- Subject** : Canopy lock, rear locking rods, landing gear axles with cone clamping devices, manual revision
- Effectivity** type: DG-1000, DG-500
variants: DG-1000S and DG-1000T
DG-500 all ser. No.'s,

- Reason** : 1. DG-1000S and DG-1000T up to ser. No. 10-144 and all DG-500:
There have been occurrences where the rear locking rod of the canopy locking mechanism of the rear canopy have rotated out of the threads in the operating mechanism despite securing with Loctite and lock nut.
As the system is similar at the front canopy both canopies may be affected.
Note: From DG-1000 ser. No. 10-145 on the system was modified for other reasons but in a way which makes rotating out of the locking rods impossible.
Note: The canopy emergency release system was designed from the beginning in a way which makes rotating out of the locking rods impossible.

Rear canopy shown

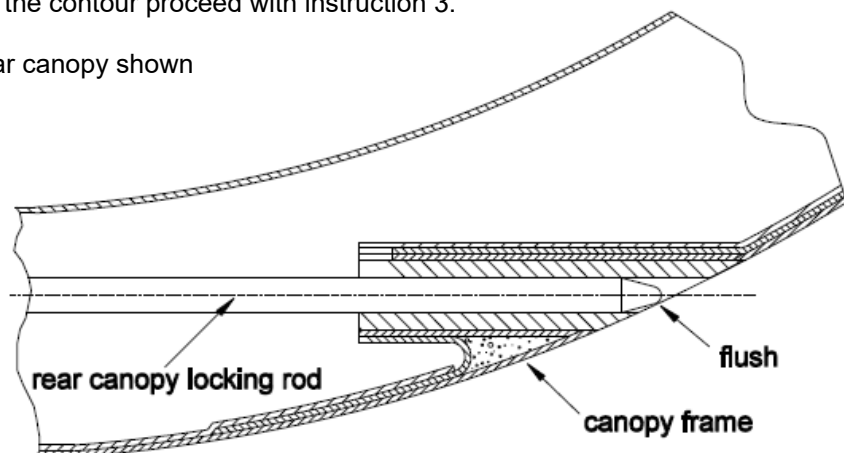
1. With each daily inspection: Check at front and rear canopy if the end of the rear locking rod doesn't protrude over the canopy frame contour with opening mechanism in fully open position. If the rod protrudes over the contour proceed with instruction 3.
